ECE/TRANS/WP.29/2007/31
5 April 2007

Proposal for the 01 series of amendments to Regulation No. 64
(Temporary use spare wheels/tyres)

Submitted by the Working Party on Brakes and Running Gear (GRRF)

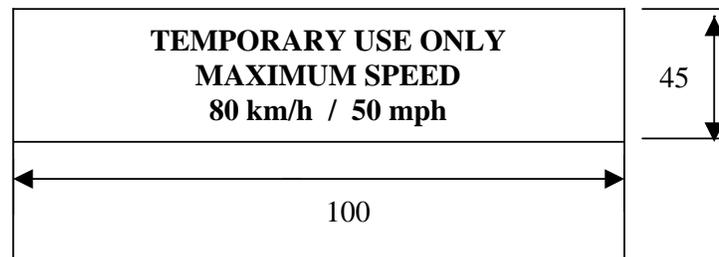
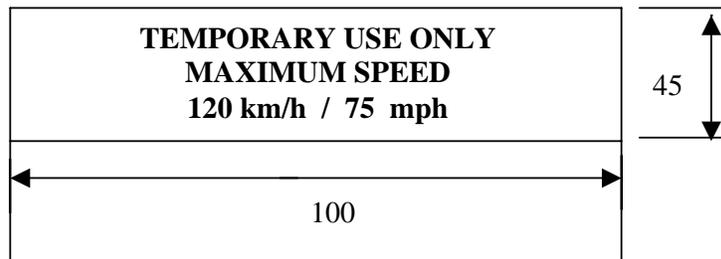
Paragraph 5.1.4.1., amend to read (the diagram is not amended):

"5.1.4.1. An 80 km/h maximum speed warning symbol arranged in accordance with the diagram below shall be permanently displayed on the outer face of the wheel in a prominent position.

In the case of vehicles intended to be sold in countries using imperial units of measurement, an additional warning symbol, identical to that described above, with the exception that the figure "80" shall be replaced by "50" and the wording "km/h" by "mph", shall be permanently displayed on the outer face of the wheel in a prominent position.

Alternatively a single warning symbol arranged in accordance with the diagram below, shall be permanently displayed on the outer face of the wheel in a prominent position.

Upper case letters shall be at least 5 mm high and the numbers "80" and "50" shall be at least 20 mm high with the elements that make up each character of the number at least 3 mm line thickness. Lower case text shall at least have a line height of 5 mm. All text shall be enclosed in a border and be on a background of contrasting colour.

The requirements of this paragraph shall only apply to types 1, 2 and 3 temporary use spare unit as defined in paragraphs 2.10.1., 2.10.2. and 2.10.3."
